UPPER TRISHULI-1 HEP (216MW)			
Client	Doosan Heavy Industries & Construction		
DHI’s Subcontractor	Power Construction Corporation of China		
REPLY COMMENT			
Subcontractor	Power Construction Corporation of China		
Incoming Document			
Title of the Document	Excavation and Initial Support Drawings of Investigation Tunnel for Powerhouse		
Document/Drawing No.	UT1-C-385-CVL-DG-65002-01 to 04	Revision	A
Review Document No.	TJ/UT1/OUT-12	Reviewed Note No.	RN-0053
Received Date	04.02.2022	Review status	AN
Outgoing Document			
Previous Reply No.	XXX	Previous Reply Date.	31.01.2022 2
Reply No.	RC-000X	Reply date	04.06.2022 2

General Comments

Drawing UT1-C-385-CVL-DG-65002-01, Rev. D

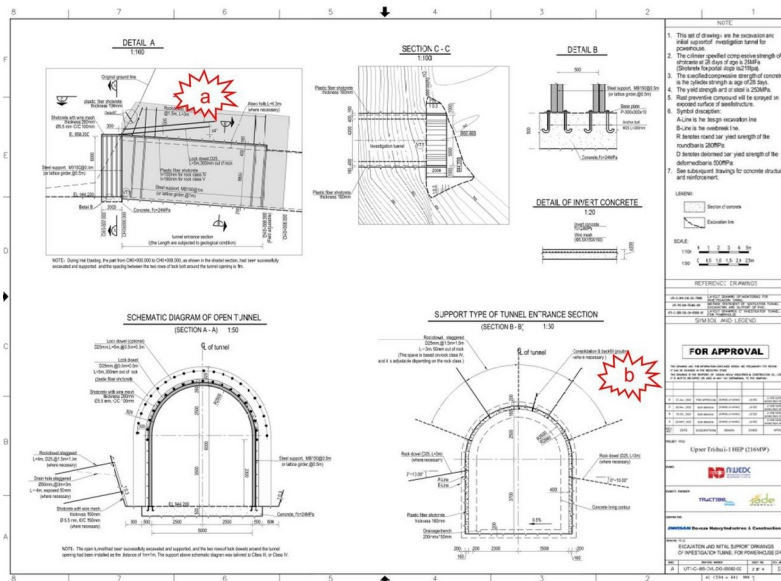
a) Support should not be specified according to overburden thickness. Delete this row.

b) There should be one thickness of shotcrete in Class IV. Use 120 mm, C25.

c) Specify clearly the support for Class V. Shotcrete thickness 160 mm, C25.

Reply This row has been deleted.

Reply This item has been modified by referring to similar file, i.e.: UT1-C-090-CVL-DG-64002-01 to 06 EXCAVATION AND SUPPORT OF ACCESS TUNNEL TO POWERHOUSE.

Reply This item has been modified by referring to similar file, i.e.: UT1-C-090-CVL-DG-64002-01 to 06 EXCAVATION AND SUPPORT OF ACCESS TUNNEL TO POWERHOUSE.

Drawing UT1-C-385-CVL-DG-65002-02, Rev. D

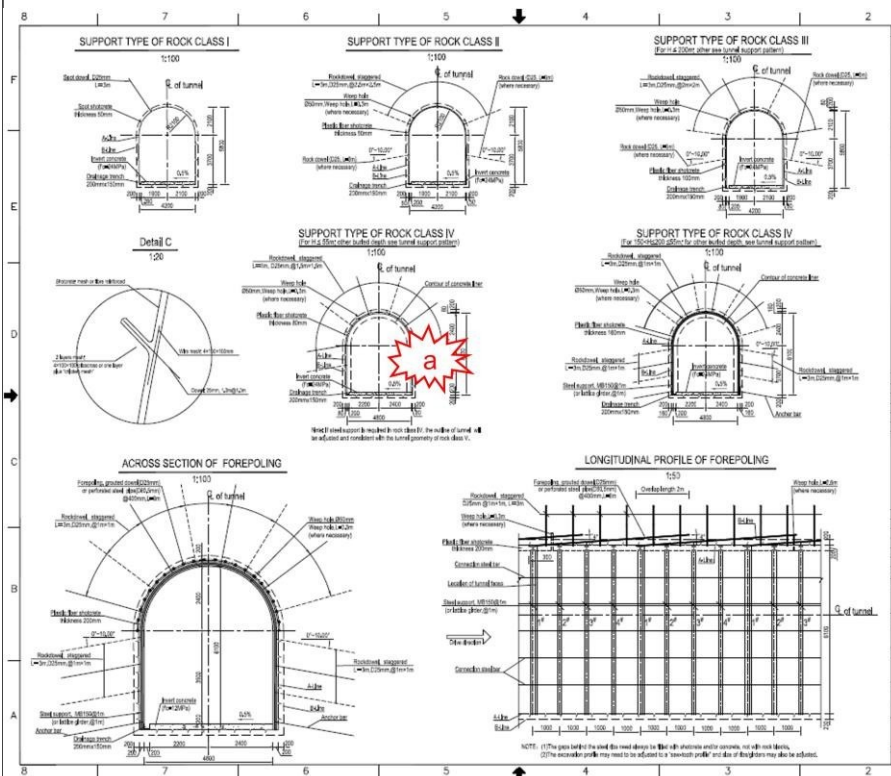
a) Angle between tunnel axis and dowels is 4°, not between horizontal and dowels.

b) Add to the sentence “This drawing... ..in the execution stage, with written approval of the OE.” This refers, of course, to all other drawings in this series.

Reply□The angle has been modified int the drawing.

Reply□The sentence has been added to below the section.

Drawing UT1-C-385-CVL-DG-65002-03, Rev. D

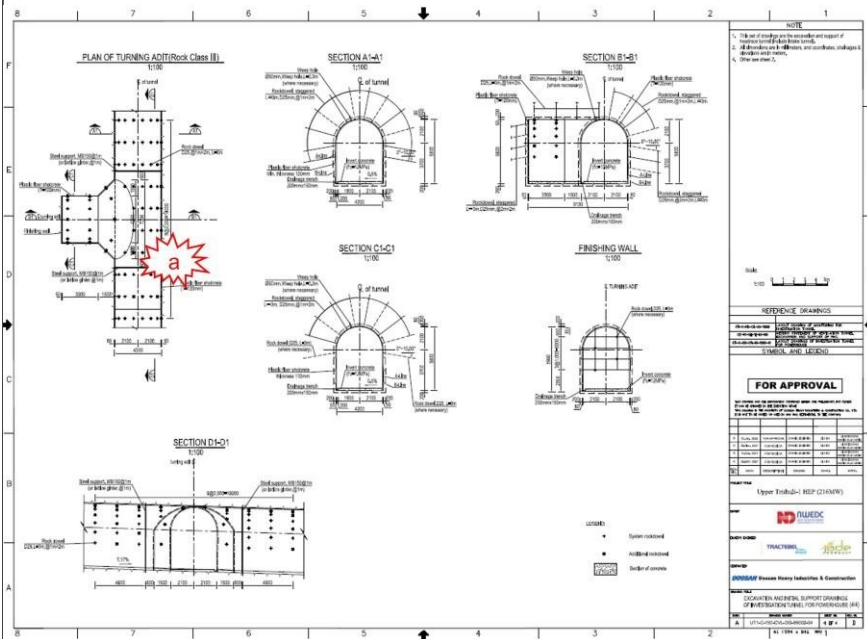
a) Do not connect the support type with overburden thickness. Use one thickness in Class IV (120 mm, C25).

Reply□This item has been modified by referring to similar file, i.e.: UT1-C-090-CVL-DG-64002-01 to 06 EXCAVATION AND SUPPORT OF ACCESS TUNNEL TO POWERHOU.
